ADDENDUM

AM 04

PROJECT : Forestside
PROJECT # : 1331.15
DATE : August 24, 2020

Title: Updated drawings

1:100 A402

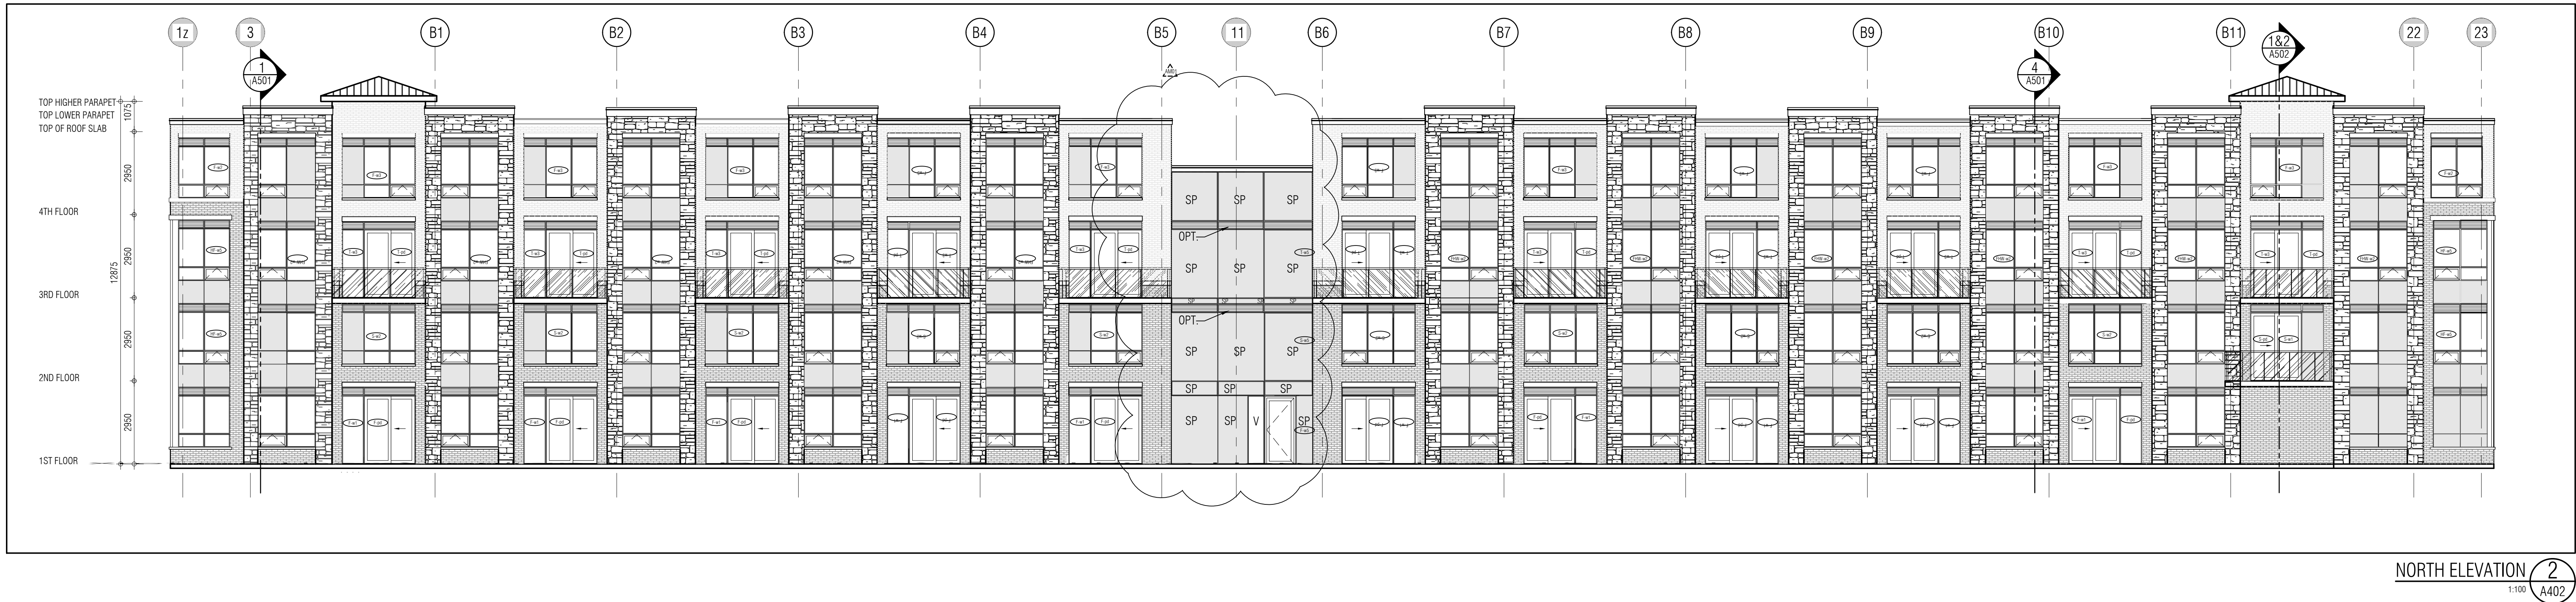
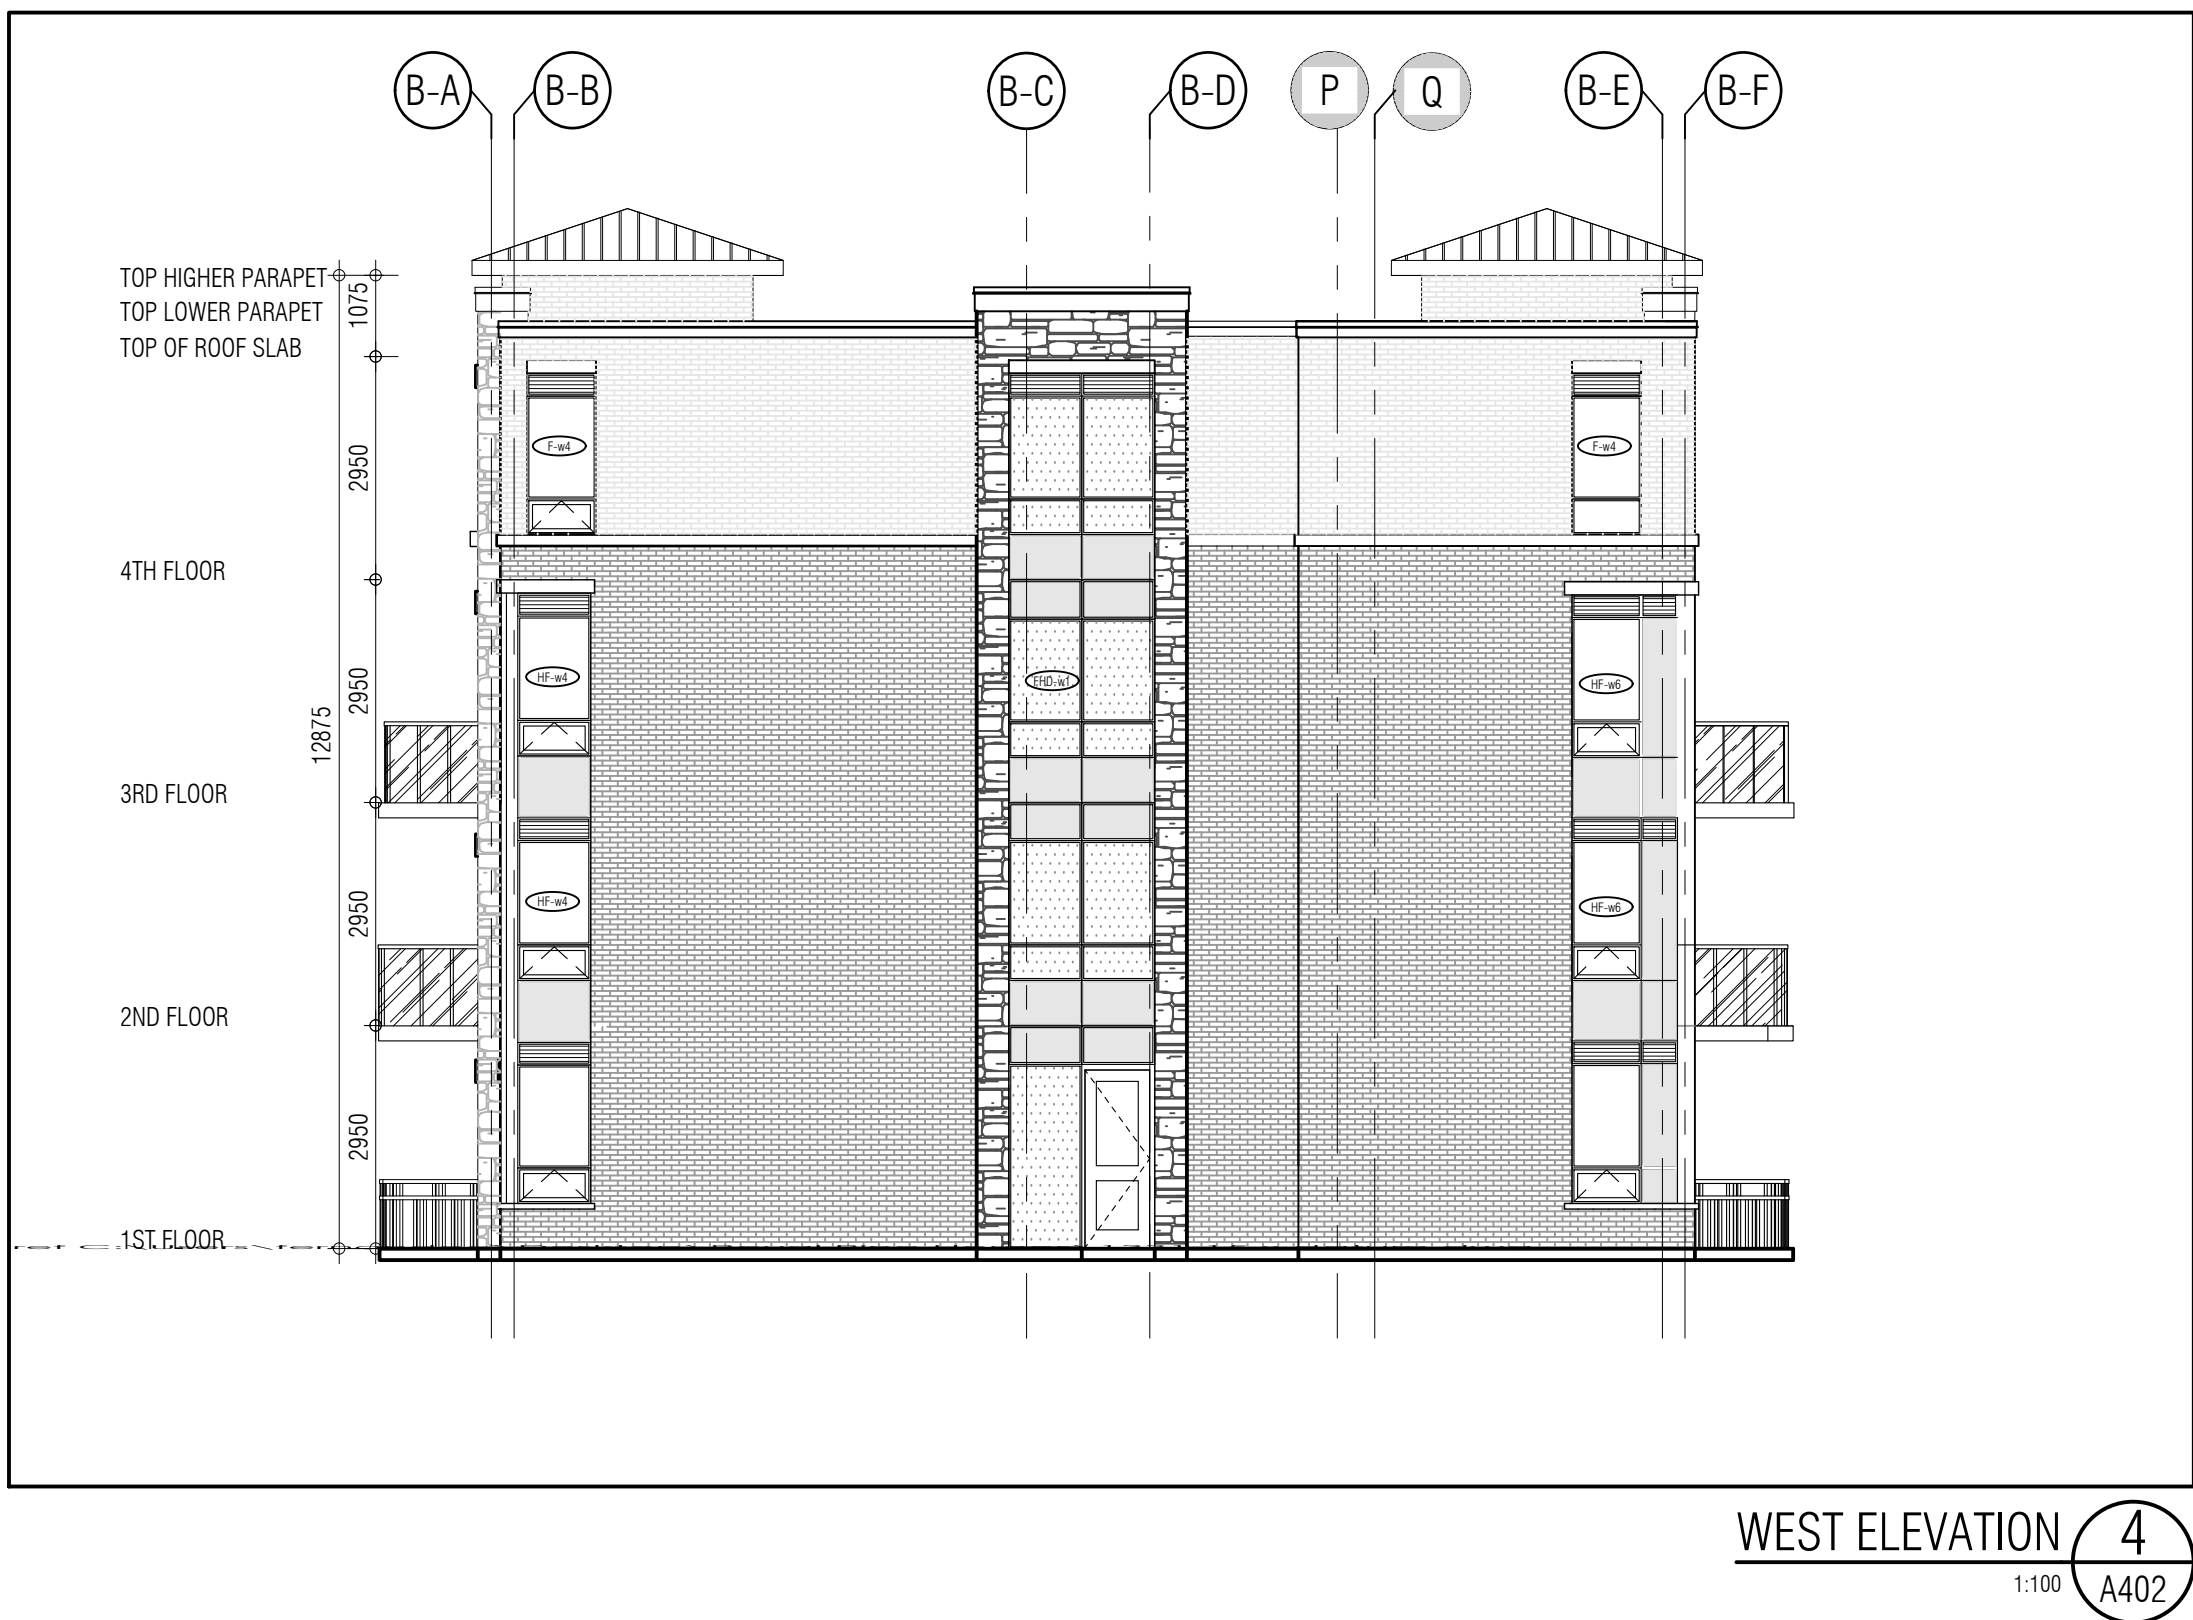
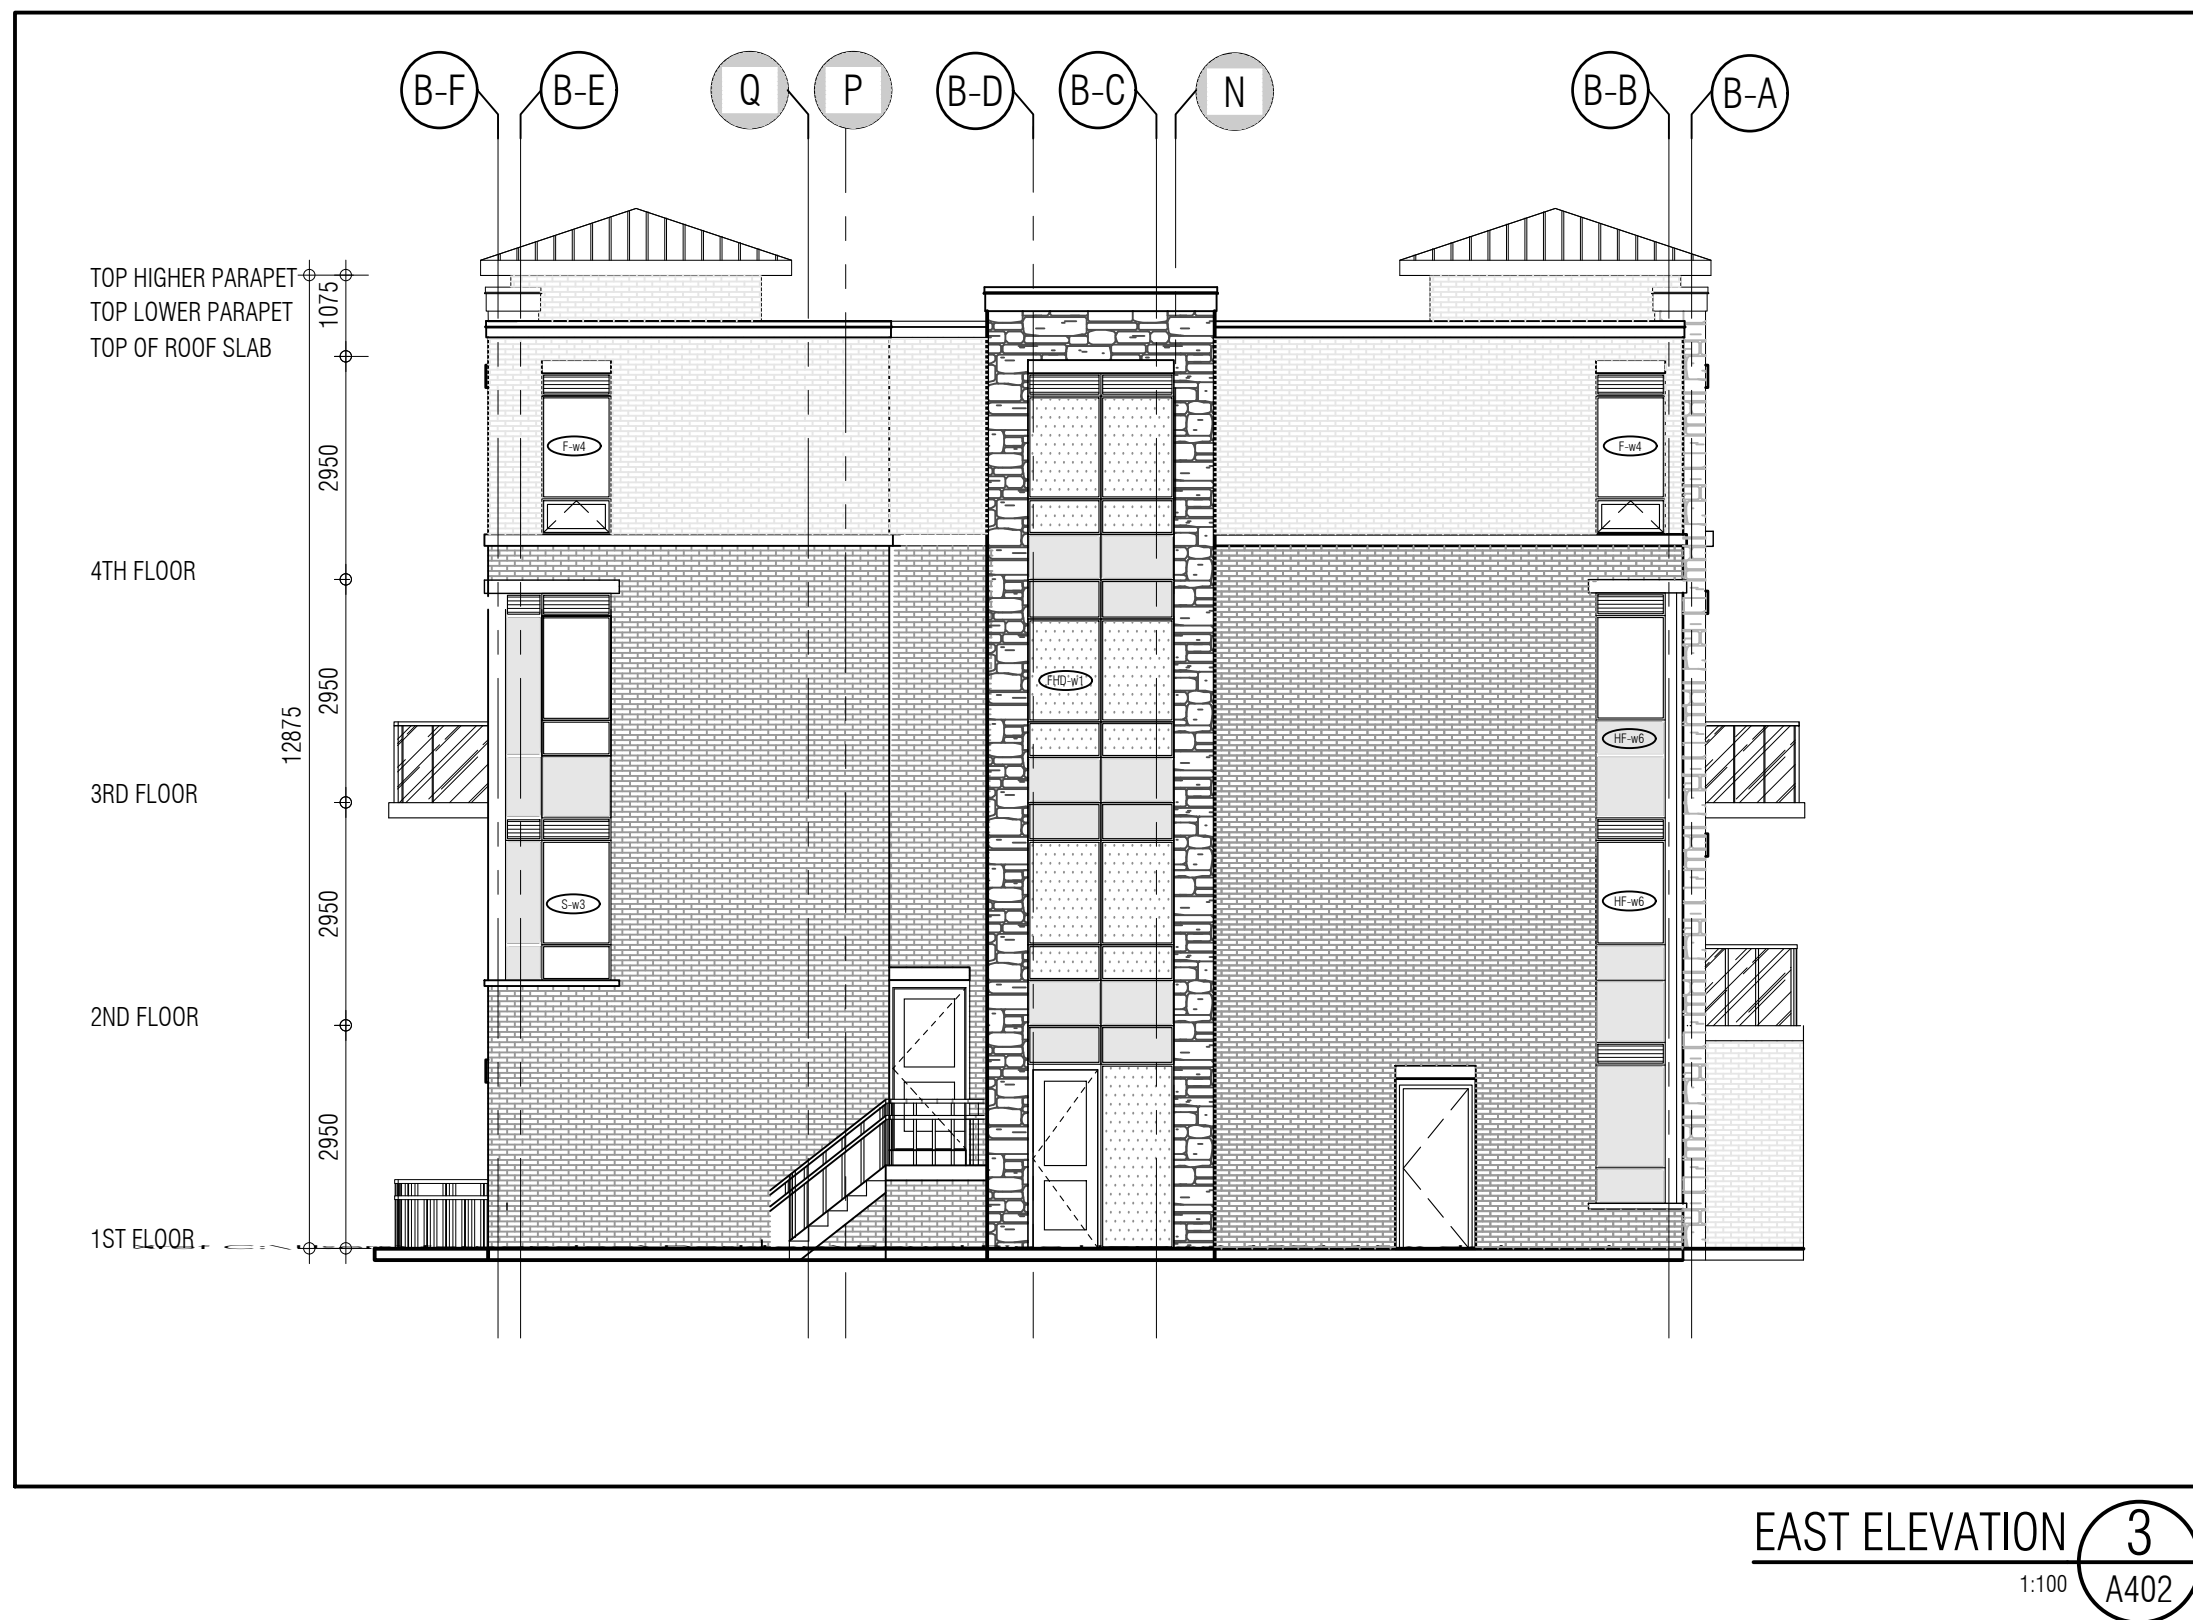
Reference:		Changes:
A-102	Wall Schedule	Revised Insulation and Sheathing on Exterior Brick, Stone, Concrete and Concrete Block walls to Spray Foam Insulation and Securock (CGC) Sheathing.
A-401 A-402 A-403 A-404	Building A Elevations Building B Elevations Building C Elevations Building D Elevations	Revised Key Plan Legend to match block elevation designation.
A-500	Building Sections	Revised all sections elevations to match updated exterior wall changes above.
A-600	Wall Sections	- Revised all wall sections to match updated exterior wall changes above. - Revised shelf angle location to be between suites on 3rd and 4th floor where it is one suite to act as Firestop and Added Firestop to floors in between suites at lower levels that do not require shelf angle.
A-900	Section Details	Revised all wall sections to match updated exterior wall changes above.
